MFN 06-173

Subject: **Partial Response to NRC Request for Additional Information Letter
No. 25 Related to ESBWR Design Certification Application –
Accident Analyses – RAI Numbers 15.0-3 through 15.0-15; 15.2-1,
15.2-2, and 15.2-4**

Partial Response to NRC Request for Additional Information

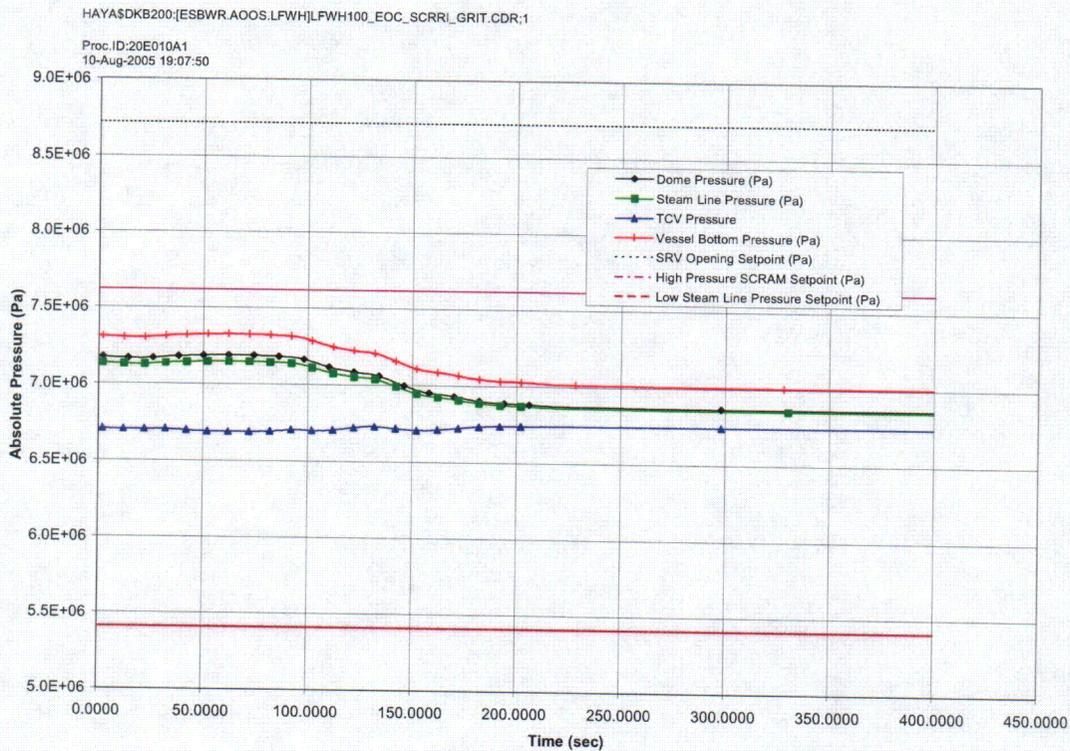
Within Chapter 4, the Rod Withdrawal Event (RWE) is classified as an AOO. Based upon the RWE description within Chapter 15 and recent conversations, it appears that GNF is attempting to reclassify the RWE into a lower frequency category.

(a) Please describe the basis for the reclassification of the RWE including initiating actions/events and mitigating strategies from all modes of operation.

(b) Please describe the potential for a "gang" withdrawal error (e.g. multiple control rods).

(c) Please identify the proposed acceptance criteria for the new event classification.

As shown in Tables 15.0-2, 15.0-7 and 15A-3 a RWE is an infrequent event and not an AOO. GE will revise Appendix 4B to be consistent with Chapter 15.

The DCD establishes the initial design and licensing for the ESBWR. Many ESBWR design features are significantly different than in the current operating BWRs, and thus, basing the event classifications on past BWR designs would result in some ESBWR events being classified inconsistently with respect to the 10 CFR regulations. To ensure and maximize consistency with the 10 CFR regulations, the ESBWR event classifications are objectively based on the specific wordings in 10 CFR regulations, regardless other plants. 10 CFR 50 Appendix A provides an explicit definition of an AOO. 10 CFR 50 Appendix A states "Anticipated operational occurrences mean those conditions of normal operation which are expected to occur one or more times during the life of the nuclear power unit and include but are not limited to loss of power to all recirculation pumps, tripping of the turbine generator set, isolation of the main condenser, and loss of all offsite power." The ESBWR design life is 60 years, and thus, any abnormal event with a probability $\geq 1/60$ per year must be classified as an AOO, and conversely, any abnormal event with a probability $< 1/60$ per year should not be classified as an AOO. However, Subsection 15.0.1.2 conservatively defines an AOO "any abnormal event that has an event probability of $\geq 1/100$ per year."

From Table 15A-3, the most likely RWE has a probability of 1/1000 per year (1 Event in 1,000 yrs). Therefore, the RWE is correctly classified as an infrequent event in Chapter 15. The analyses that determine the RWE probability are described in Subsections 15A.3.11, 12 and 13. Because a RWE is an infrequent event, (1) Table 15.0-5 provides its acceptance criteria, and (2) "(core-wide AOOs only)" after "No fuel centerline melt," "Energy generation is < 170 cal/gm (RWE during startup only)," and note "*" are being deleted from Table 15.0-3.
